HYUNDAI

Technical Service Bulletin

GROUP Interior	NUMBER 20-BD-005H
DATE March, 2020	MODEL(S) Sonata (DN8a)

SUBJECT: INSIDE DOOR HANDLE REPAIR

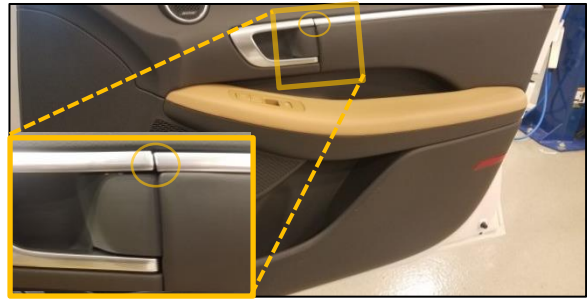
1. Inspect the area where the inside door handle meets the chrome accent. If the inside door handle is slightly raised above the door trim, repair is required.

2. Insert a **0.3mm feeler gage** into the gap between the door handle and the chrome accent for inspection.

If the inside handle is flush or slightly lower than the door trim, the gap should have a measurement of 0.3mm (or more). If the measurement is below 0.3mm, repair is required.

**NOTICE**

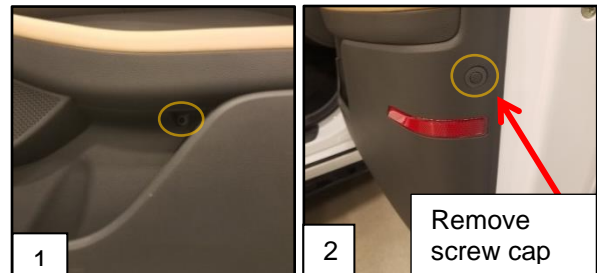
If the door handle is higher than the chrome accent, repair the door trim even if the gap measures at or larger than **0.3mm**.

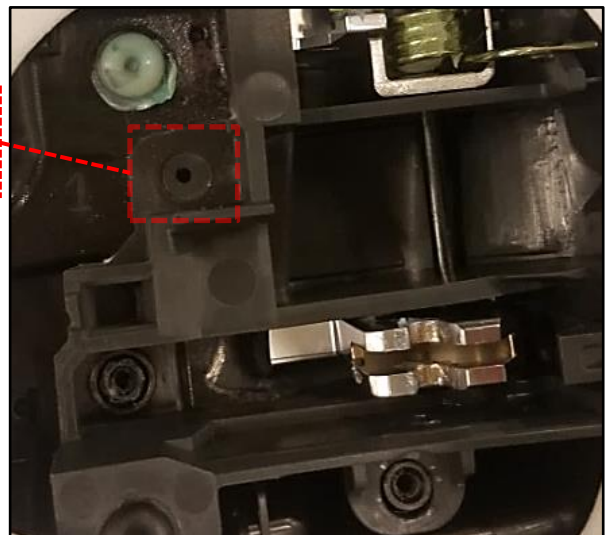
7. Use a flathead screwdriver to lift the indicated area of the inside door handle assembly.

8. Insert the repair kit washer behind the lifted inside door handle area.

NOTICE

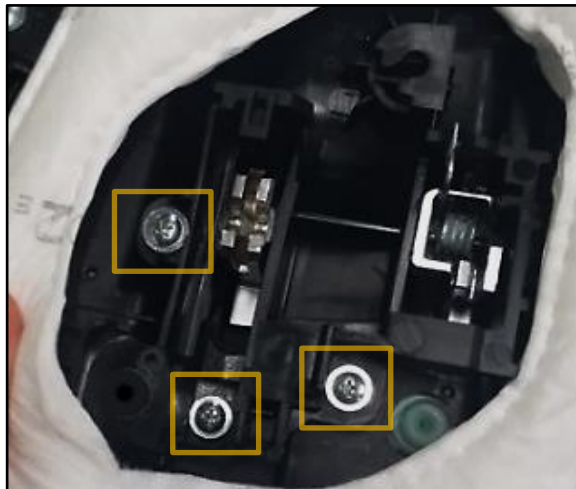
If the washer cannot be positioned behind the inside door handle assembly, proceed to the alternate method below.

- A. **Alternate Method**

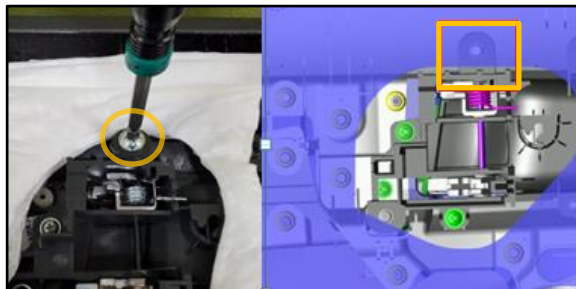
Remove the heat welded tab with a utility knife, then insert the metal washer underneath the door handle assembly.

- B. Insert the repair kit screw into the former heat welded tab.
